SERVICE BULLETIN

TITLE: STABILIZERS - INSPECTION/REPLACEMENT OF ELEVATOR BALANCE WEIGHT ASSEMBLIES

SYNOPSIS OF CHANGE

Inspection of Elevator Balance Weight Assembly
Figure 1

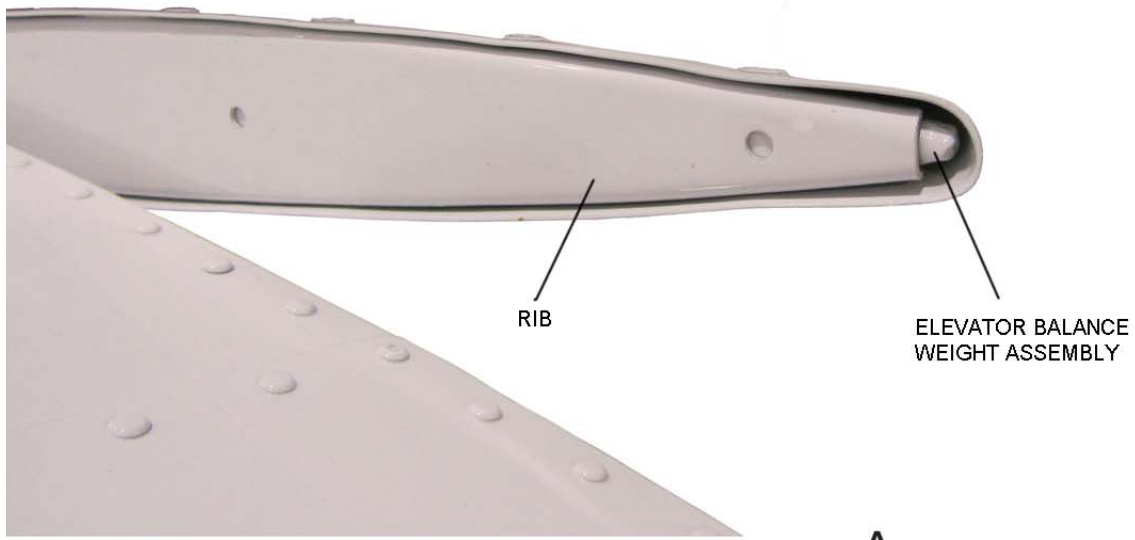
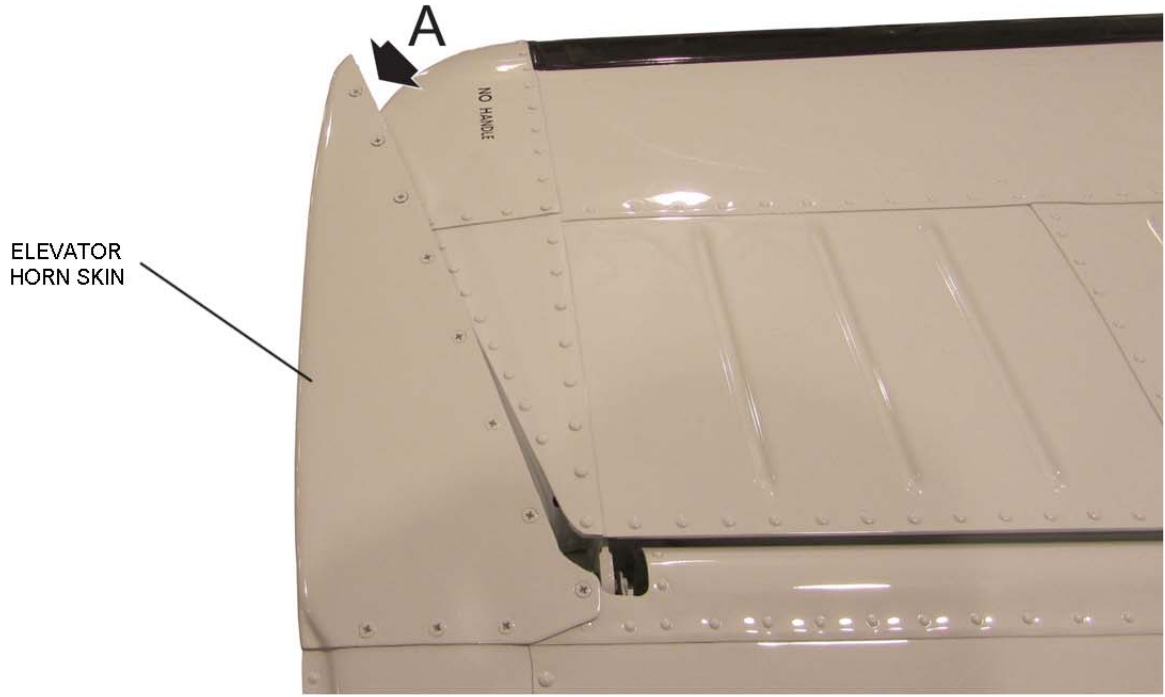
Elevator weights have been built to multiple type design revisions and may have five (5) inserts as shown in Figure 1 or four (4) inserts.

- (2) Gain access to the elevator and locate the existing elevator balance weight assembly that is installed under the elevator horn skin. Refer to Figure 1 and Figure 2.

- (3) Visually inspect to determine if the existing elevator balance weight assembly is in position and protruding from the edge of the rib. In addition, verify that the elevator balance weight assembly attachment screws on upper and lower surfaces are secure and the installation holes show no sign of discoloration. Refer to Figure 1 and Figure 2.

- (a) If the existing elevator balance weight assembly is in position, protruding from the edge of the rib, the attachment screws are secure and the installation holes show no sign of discoloration, no further action is required for this Service Bulletin. Proceed to Step (13).

- (b) If the existing elevator balance weight assembly has become dislodged, the attachment screws are not secure, or the installation holes show signs of discoloration, proceed to Step (4).
